MEMORANDUM

From:	Catherine Brimble Senior Landscape Officer		
Service	SDL Landscape and Trees	App No:	250399
Address:	Parcel R10 South Wokingham, Phase 2b, Parcel R10.		
Proposal:	Application for the approval of reserved matters pursuant to condition 1 of outline planning permission ref. 191068 for the erection of 215 dwellings with layout, scale, appearance, and landscaping to be considered.		
Type of Development:	Major Dwellings (10+)		
Site Visit Made:	Yes/No

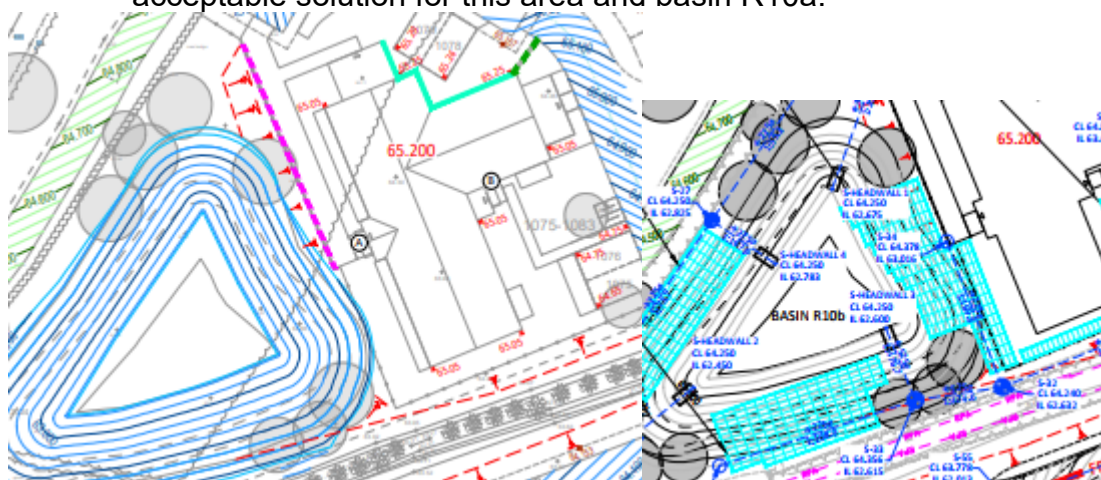
- We will need to understand the levels of the attenuation basins in relation to the surrounding development levels. The basin cross sections give the basin invert level but don't give spot levels of the top of the basins. Also only a few of the contours around the basin are labelled. We will need to see all contours labelled to understand their relationship to the adjacent development parcel levels. Slightly more levels information is found on the Engineering Layout drawing submitted under condition app 250665 and indicates there will be a retaining wall between Basin R10b and apartment block 5 which can be seen in the extract below indicated as pink dashed line. The other extract shows the location of the underground cell storage areas. There

is also concern regarding the proximity of the edge of the attenuation basin and the existing ditch and its associated vegetation to be retained. We will need to have fully detailed landscape cross sections to show exactly how this area (and basin R10a) will be designed and suggest and expect that some changes will need to be made to find an acceptable solution for this area and basin R10a.

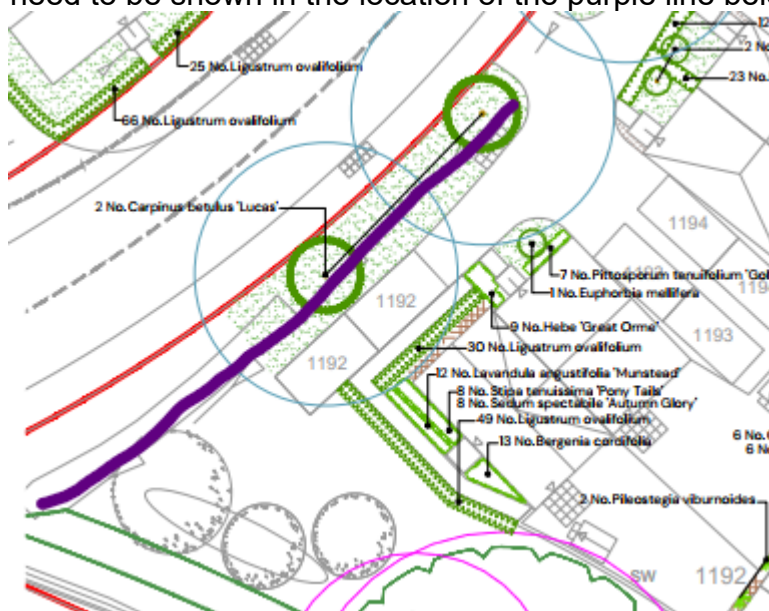
9. Suggested additional planting should be considered in the following locations:
 - Two additional trees in the rain gardens associated with the parking for apartment block 6 which are to the rear of plots 1107 & 1108.

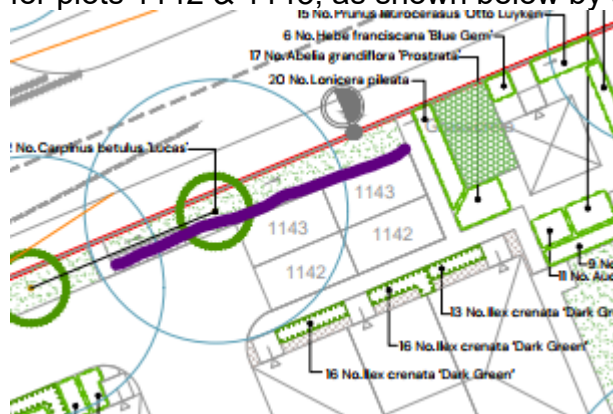
- Additional tree planting in rain gardens to the fronts of plots 1150, 1151/1152, and to the side of plot 1210.
- A specimen tree to the side of plot 1197 on corner of the tertiary road and the link road.
- A new hedgerow at site entrance south of the link road to the west and north-west of plots 1192 & 1193. This partially appears on the presentation layout and the Detailed Public Open Space Soft Landscape Proposals drawing but is not labelled. A new hedgerow will need to be shown in the location of the purple line below.
